**Subject** ▶ Change of Slider and Plane Bearing

**For Models** ▶ JR3000V (Recipro Saws)

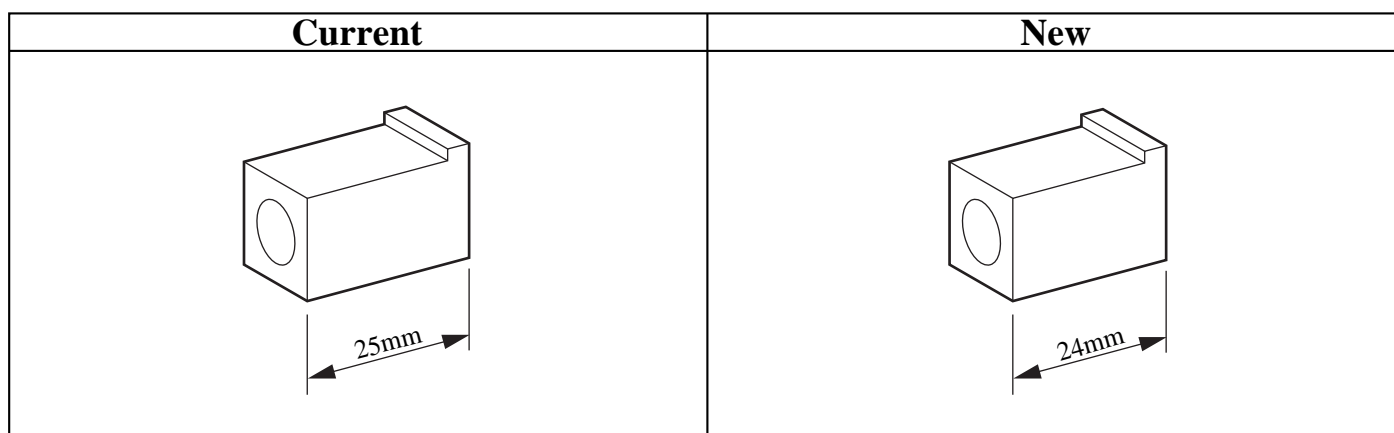
1) Change on Slider : Shape and thickness of slider block have been changed.

2) Change on Plane Bearing 12.7 : Plane Bearing at moter housing side has been shortened by 1mm to make a clearance for new Slider block.

Current Plane Bearing may be used only at blade side after above change.
